(RESPONSES TO REVIEW COMMENTS)

AT&T SITE ID:
CRAN_RANM:
PHX01_010_A
5401 N SCOTTSDALE RD
SCOTTSDALE AZ 85250

SHEET TITLE:
PHOTOMETRIC
STUDIES

SL-1

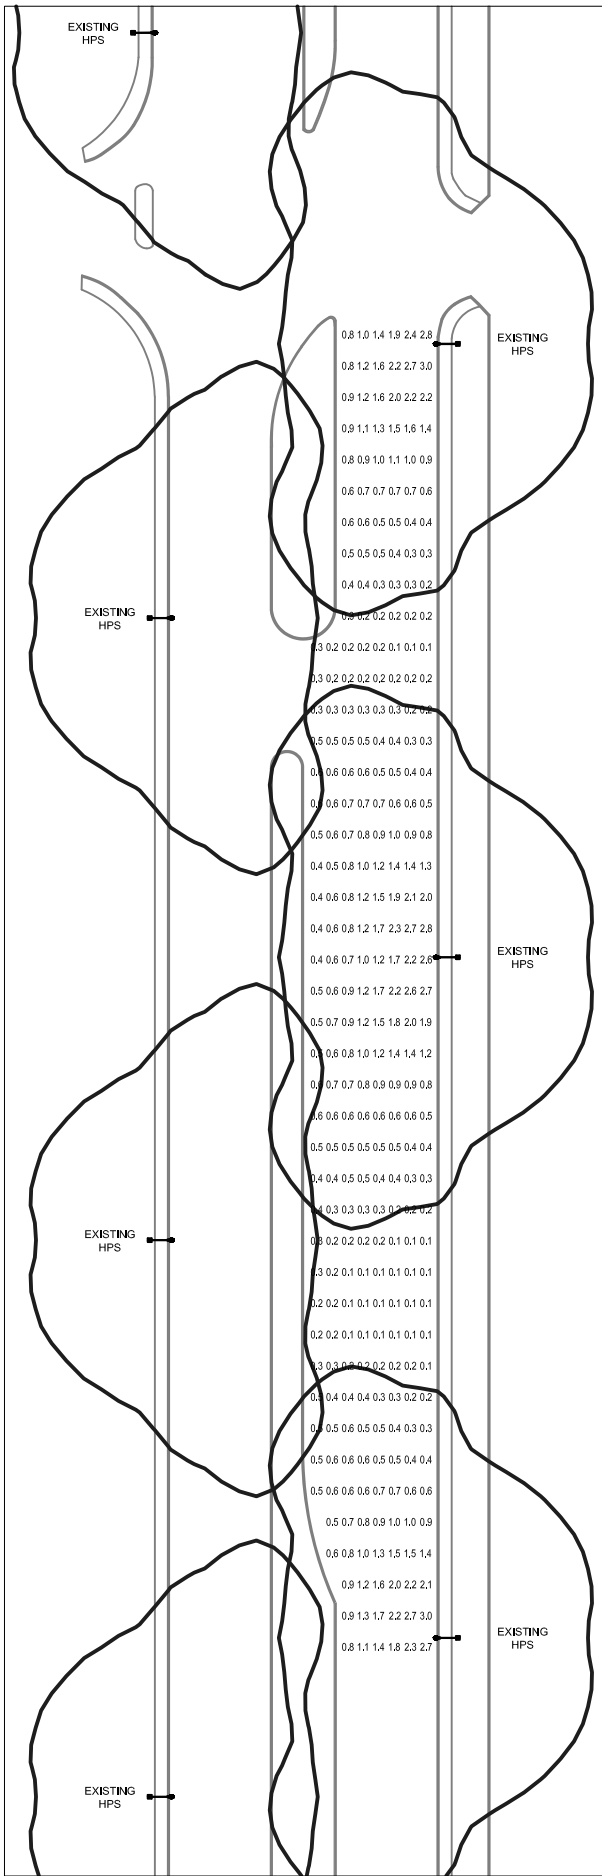
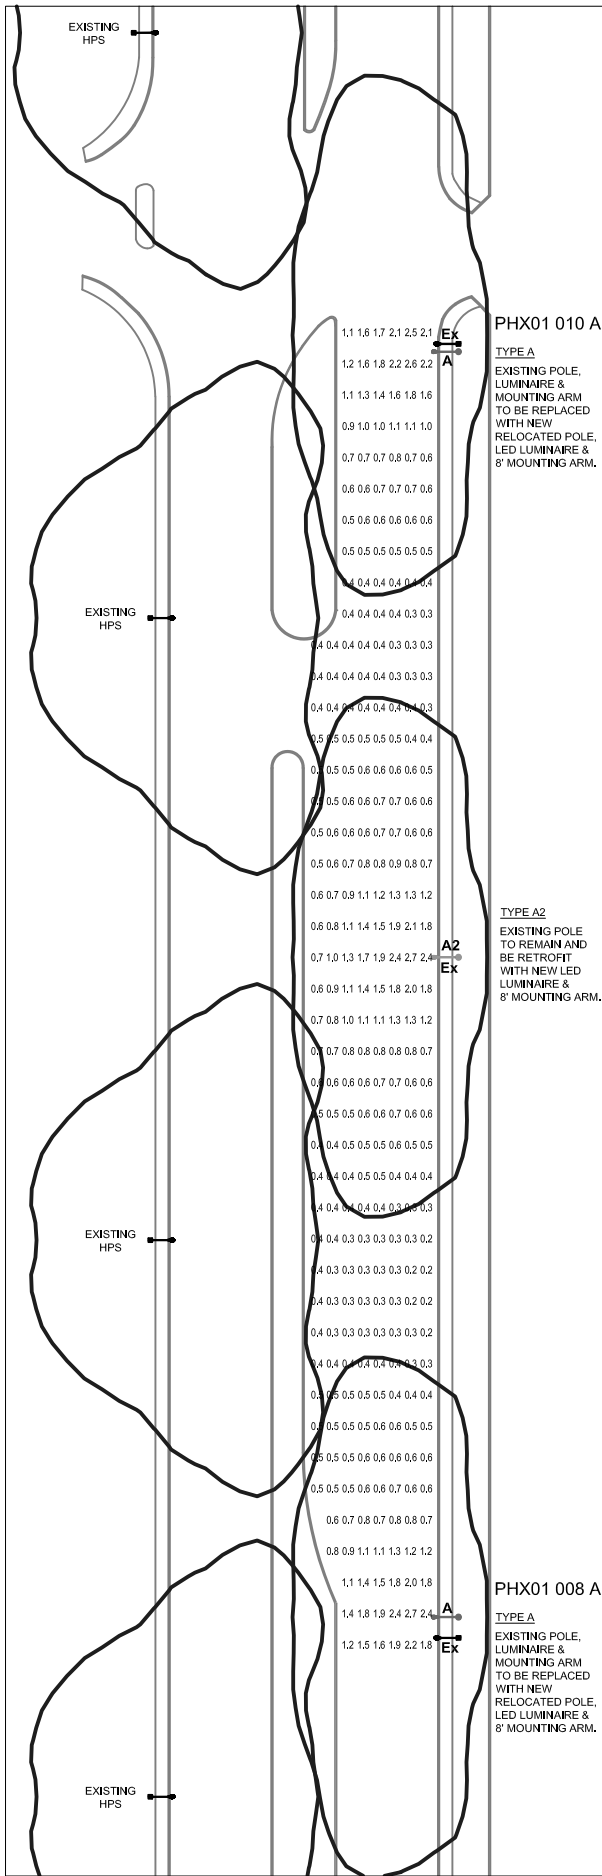
7. Sheet SL-1:

- a. Please verify the location of Street Light 008-A. The November pre-application submittal showed Street Light 008-A located on the north part of the plan.

However, this submittal shows Street Light 008-A located on the south part of the plan.

- b. Per previous discussion, it was noted that the light output on the streetlight photometric plan is shown between the light poles in accordance with industry standards. Please note this on the plan and reference any applicable standards documenting this practice.

8. Luminaire Data. Below are the Engineering Department comments which utilized the City of Scottsdale standards:
 - a. The average lighting levels do not appear to meet City of Scottsdale's requirements.
 - b. The 13,500 initial lumens are used for a 200' spacing on major arterials. Since the poles are spaced 250' apart, the initial lumen level should be higher. Please update accordingly. Please reference the City of Scottsdale DSPM at:
<https://www.scottsdaleaz.gov/Assets/ScottsdaleAZ/Design/DSPM/DSPM+2018.pdf>.
If you have any questions, please contact Paul Mood at 480-348-3573 or pmood@paradisevalleyaz.gov.

1. **RESPONSE TO REVIEW COMMENT #7A:**
THE 2-3-20 & NEW SUBMITTAL SHOW THE #08 & #10 POLES IN THE CORRECT LOCATIONS. THEY WERE ERRONEOUSLY REVERSED IN THE NOV 2019 SUBMITTAL.

2. **RESPONSE TO REVIEW COMMENT #78:**
LOCAL STREET LIGHTING IS MOST OFTEN BASED UPON THE INFO CONTAINED IN THE DOCUMENT TITLED: RECOMMENDED PRACTICE FOR DESIGN AND MAINTENANCE OF ROADWAY & PARKING FACILITY LIGHTING (RP-8-18), WHICH IS PREPARED BY THE ILLUMINATING ENGINEERING SOCIETY (IES) AND THEN ADOPTED BY ANSI AS AN APPROVED NATIONAL STANDARD. SECTION #3.2.3.1.1 DESCRIBES THE PREFERRED LOCATIONS FOR CALC POINTS, AND INCLUDES FIGURE 3-6, WHICH SHOWS THAT THE PREFERRED LOCATIONS ARE ONLY FROM ONE LUMINAIRE TO THE NEXT LUMINAIRE ON THE SAME SIDE OF THE ROAD. THIS IS REFERRED TO AS "ONE LUMINAIRE CYCLE."

3. **RESPONSE TO REVIEW COMMENT #8A:**
THE STATEMENT IN THE REVIEW COMMENT IS CORRECT -- THE PROPOSED DESIGN DOES NOT MEET CURRENT COS STANDARDS. HOWEVER, UPON SHOWING THE COS SEVERAL DESIGN VERSIONS UTILIZING DIFFERENT LUMINAIRE WATTAGES AND DISTRIBUTIONS, IT WAS AGREED THAT IT WAS SIMPLY IMPOSSIBLE TO MEET THE CURRENT STANDARDS UTILIZING THE MANDATED NEW MOUNTING HEIGHT AND EXISTING POLE SPACING. THE CITY AGREED TO ADDRESS THE EXCESSIVE POLE SPACING AT A FUTURE DATE, AND AGREED TO ALLOW OUR PROPOSED DESIGN SOLUTION.

4. **RESPONSE TO REVIEW COMMENT #8B:**
THE PROPOSED DESIGN IS BASED UPON A LUMINAIRE WITH A TYPE-IIW DISTRIBUTION, A COLOR TEMP OF 3000K, AND AN INITIAL OUTPUT OF 13,400 LUMENS. THIS IS INDEED ALL DIFFERENT FROM THE SPECS CONTAINED WITHIN COS' CURRENT STANDARDS, BUT WERE APPROVED BY THE COS TRAFFIC ENGINEER DUE TO THE CONSTRAINTS IMPOSED BY THE EXISTING POLE LOCATIONS/SPACING AND MANDATED NEW LUMINAIRE MOUNTING HEIGHT. OUR PROPOSED DESIGN WAS DEEMED TO BE THE BEST APPROACH/COMPROMISE FOR THE PARTICULAR LOCATION.
